Report for the Grenfell Tower Inquiry

The application for Building Regulations approval (Part B Fire) in relation to the refurbishment of Grenfell Tower - extent of control, the Building Control process adopted, the referenced guidance and practices adopted

Beryl Menzies FCABE PPBEng CBuildE CABE MRICS

October 2019 (Amended April 2020)

PROJECT
FIRE STRATEGY

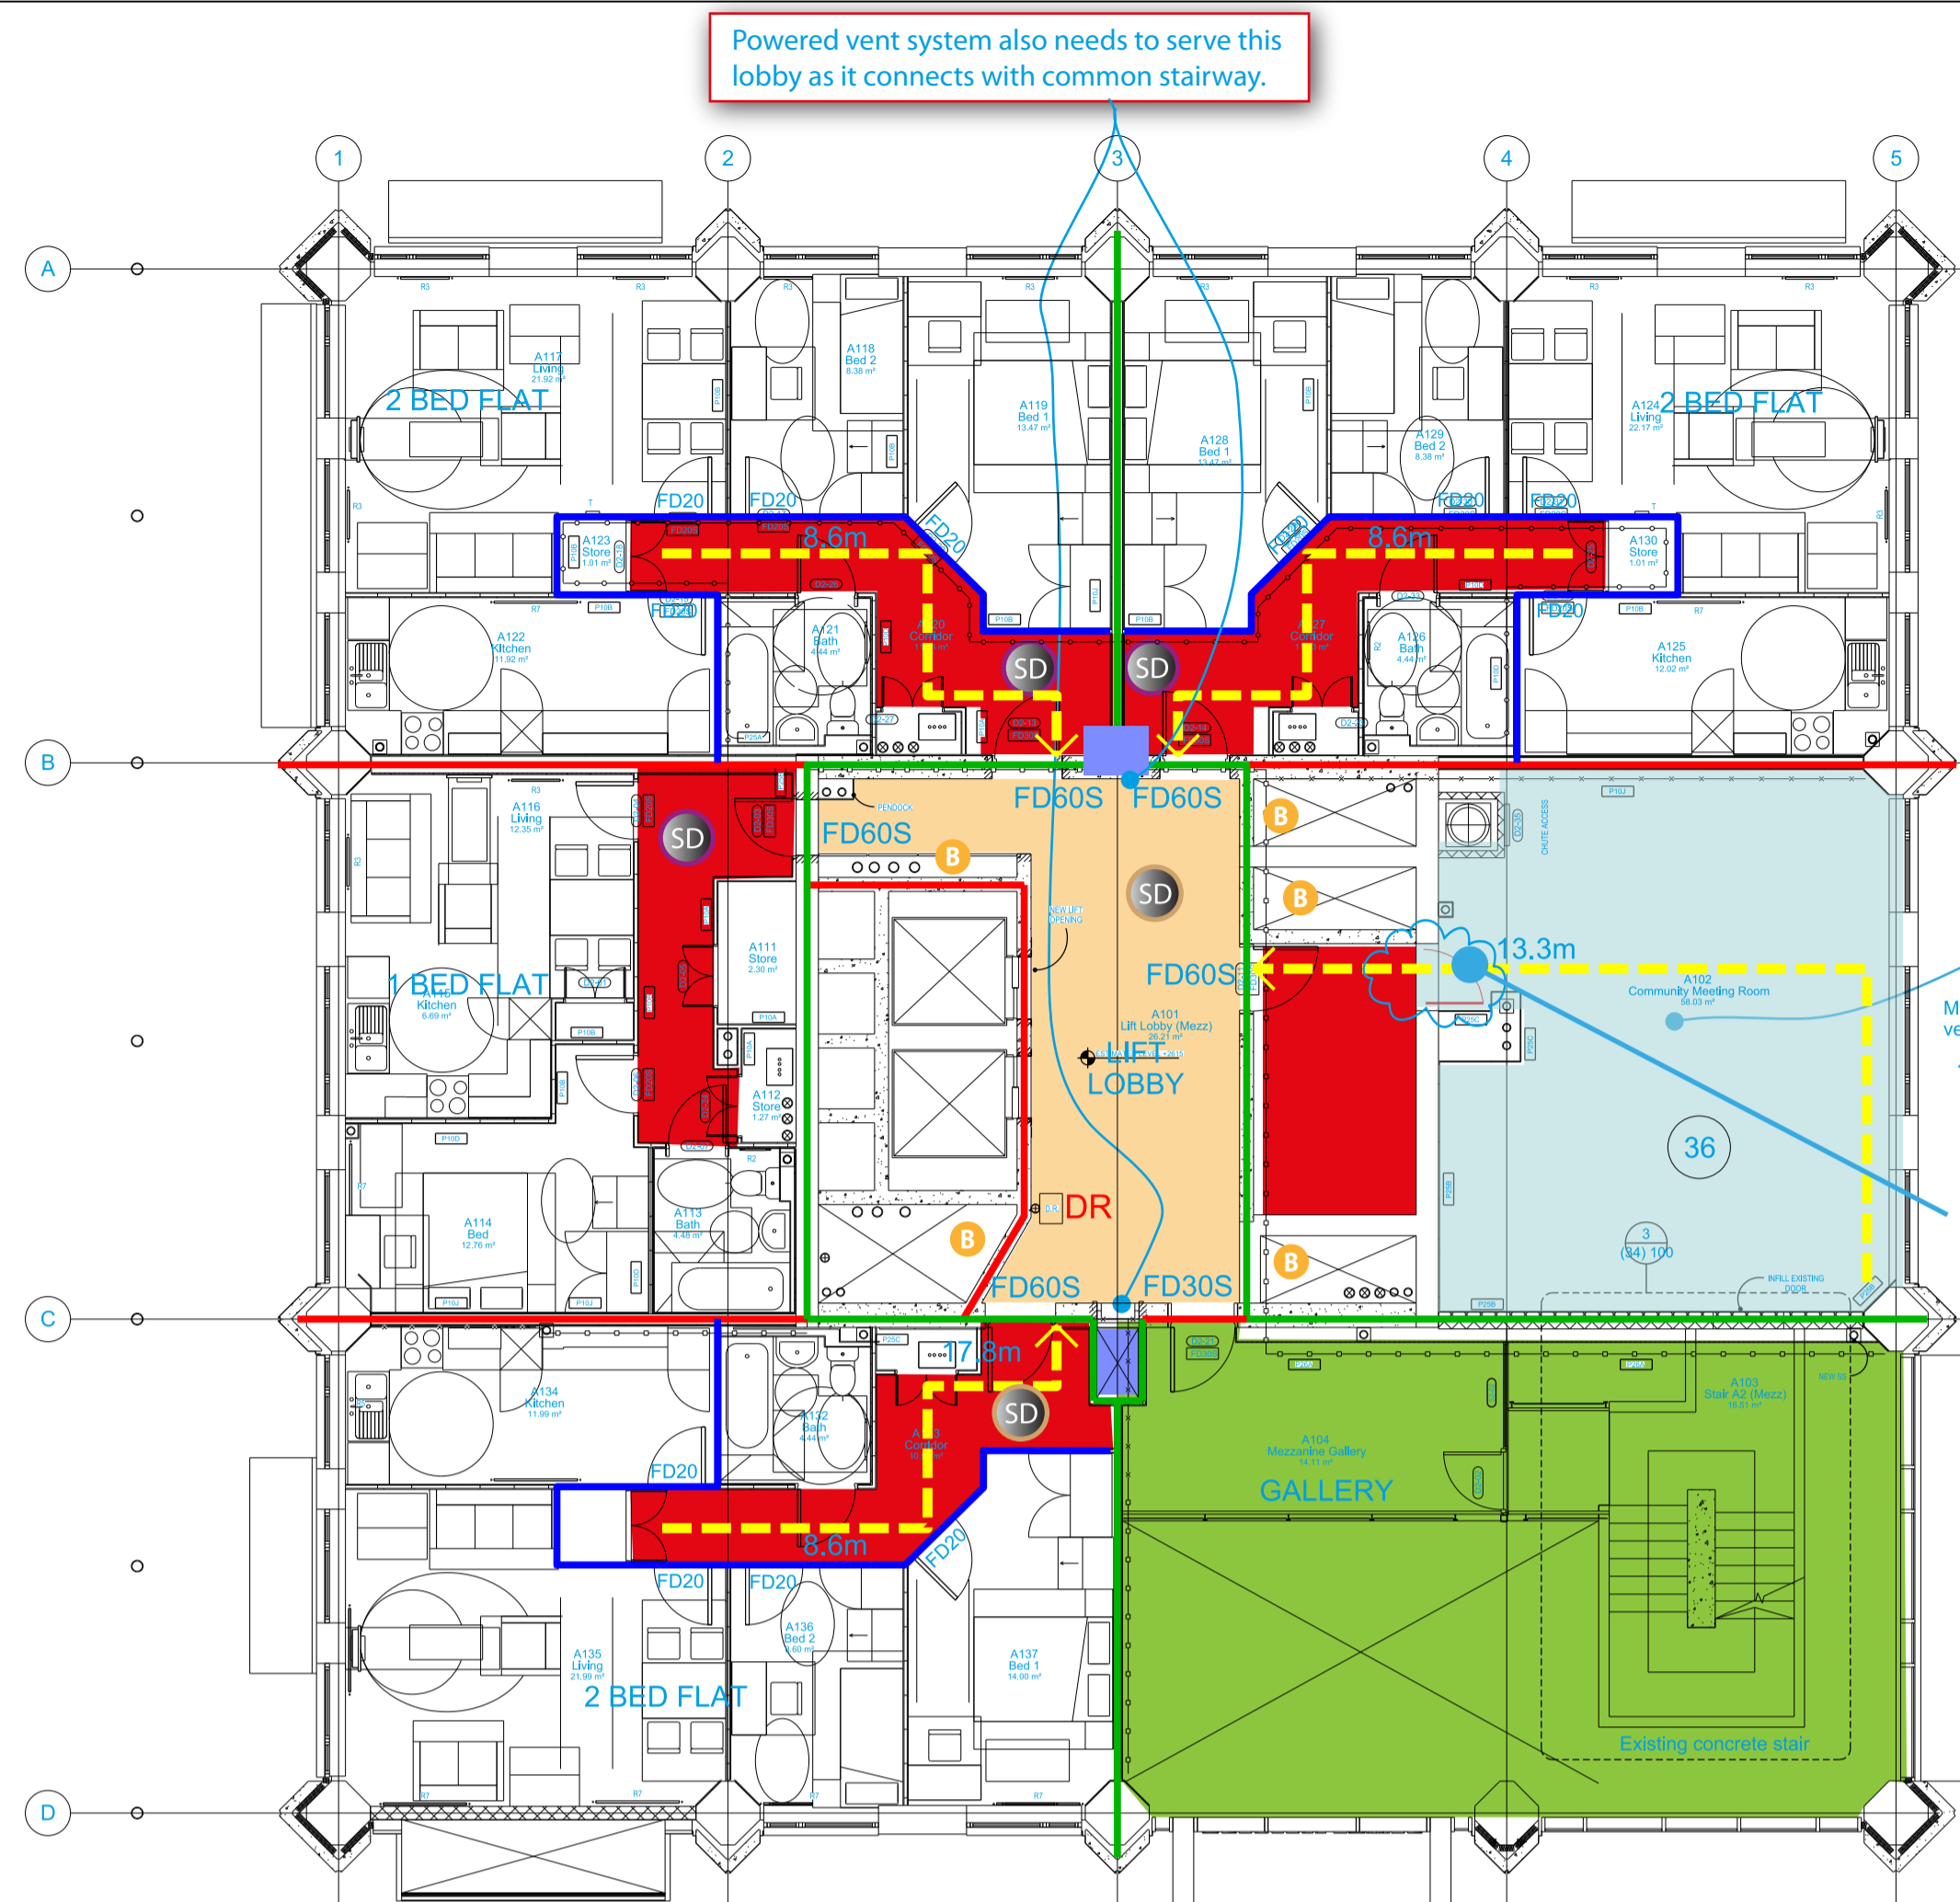
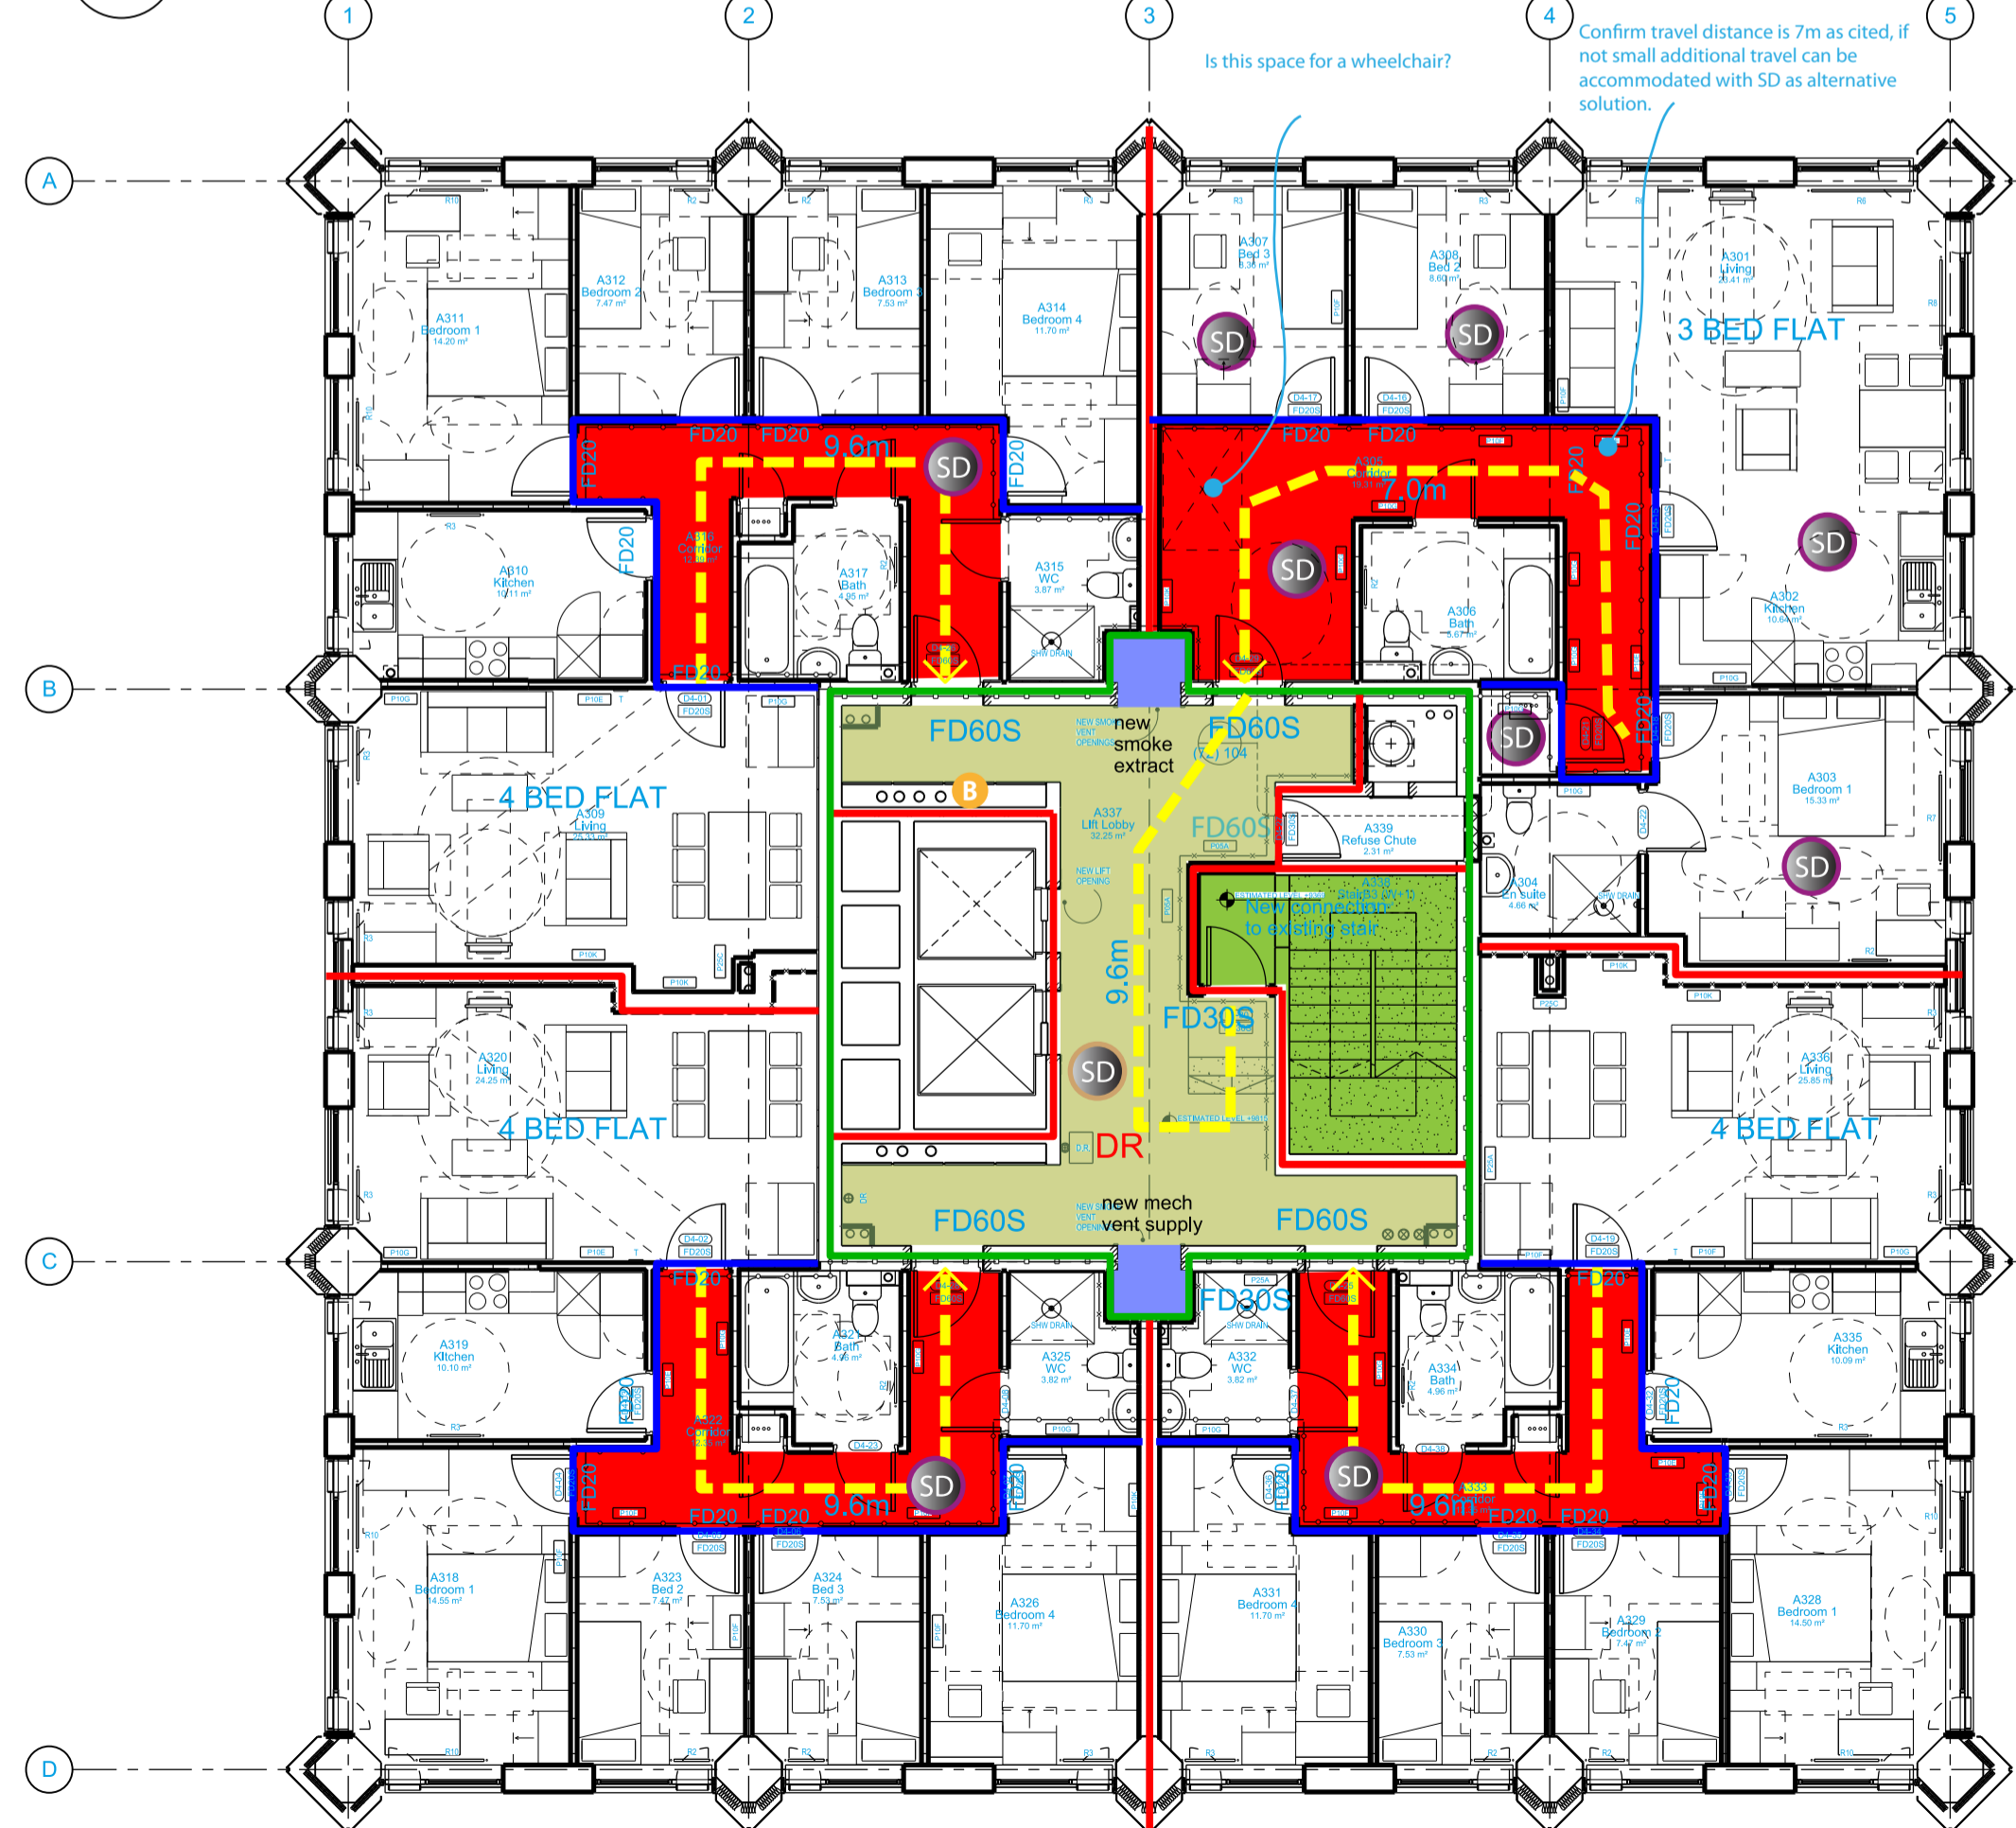
This is a room. Venting the room would not provide the same level of protection as venting a lobby thereto.

Provided that the lift lobby is vented - in this case an additional unvented (red) lobby separation to the residential escape is considered appropriate. The lobby in red should be completed with inner and outer FD30S doors.

Route of powered vent duct, is not shown carried down to serve lobby

Layout of boxing club? Distances given are direct distances with area remain open plan?

Residential flat opens directly into stairway without common ventilated lobby provided on other floors.
